REMARKS

Appl. No. 10/663,247 Amdt. Dated: 03/04/2005

Reply to Office Action of 11/04/2004

ANNOTATED DRAWING SHEET TO SHOW AMENDMENT FIGURE 1

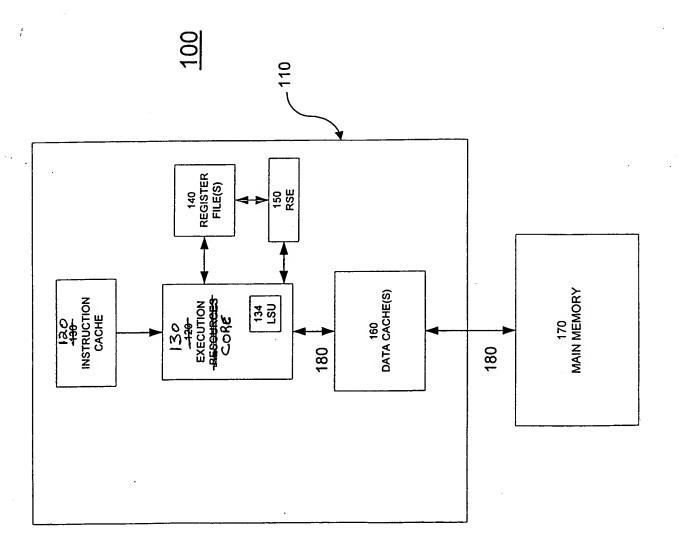
The reference numbers 120 and 130 on the original drawing of Figure 1 is inconsistent with the usage in the paragraph in the specification beginning at page 6, line 10. In this paragraph, the instruction cache is designated using reference number 120 while the reference number 130 refers to the

execution core. Additionally, the specification refers to an "execution core" and not "execution resources" in the same paragraph.

Thus, Applicant has amended Figure 1 by swapping reference numbers 120 and 130 and by replacing "RESOURCES" with --CORE--.

Applicant has amended Figure 1 by swapping reference numbers 120 and 130. Applicant has further amended Figure 1 by replacing "RESOURCES" with --CORE--.
